## **Statement on Alternative Development for the Lake Okeechobee Watershed Project to the Working Group of the South Florida Ecosystem Restoration Task Force**

April 20, 2006

Source: South Florida Water Management District news release dated, (9-7-05)

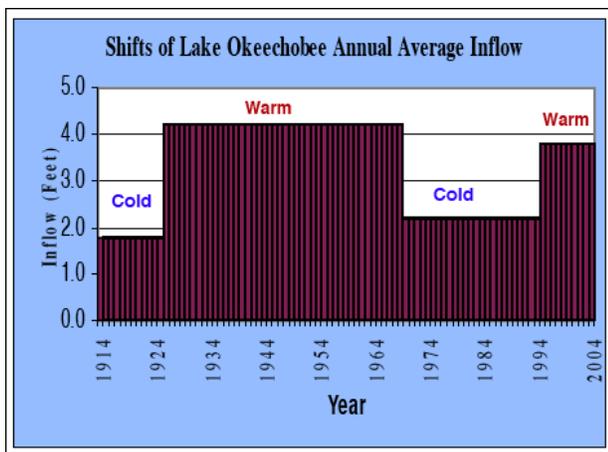
Florida has experienced very wet years over the past two summers and it is increasingly clear that the weather pattern has changed from a dry to a wet cycle. Based on current understanding of the AMO, South Florida can expect increased rainfall for another decade or two. This means that the average annual inflow of water roughly doubles, and with an average of four feet of net input, will regularly surpass the storage currently planned north of Lake Okeechobee. Please refer to the graph below, published by the South Florida Water Management District, which demonstrates this cyclical weather pattern and the likely increases in inflow during a warm cycle. Greater amounts of rain and flow will occur in the EAA as well, which will alter plans to send lake water south. CERP was based on the period from 1965-1995, almost perfectly overlaying the "cold," or drier cycle, and therefore underestimated the storage and treatment needs of this wetter cycle.

Although the average inflows depicted in this figure do not show annual climate variability that has important implications, they are useful for seeing overall trends.
